PLANNING DEPARTMENT STAFF REPORT DESIGN COMMITTEE MEETING

February 21, 2013

<u>ITEM III-B:</u> DESIGN REVIEW PERMIT- 1241 PLEASANT GROVE BL. - STARBUCK'S - FILE# 2007PL-113 (DRP-000468).

Figure 1: Surrounding Zoning

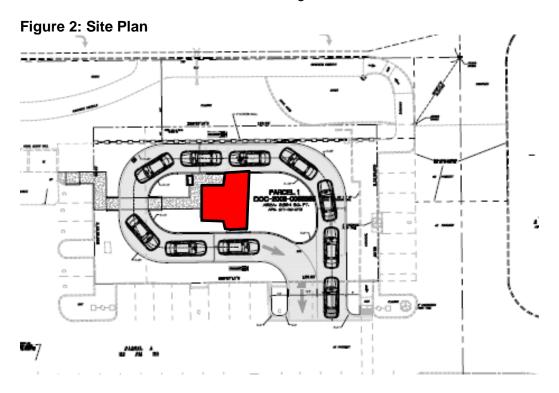
Location: The project site is located at 1241 Pleasant Grove Bl. The site is physically located on the south side of Pleasant Grove Bl. and east of Foothills Bl.

Roseville Coalition of Neighborhood Associations (RCONA): The site is located in the Kaseberg-Kingswood neighborhood association, which is currently inactive. Public Hearing notices were mailed to all property owners within a 300 foot radius of the project site and the City has not received any inquiries or comments regarding the project.
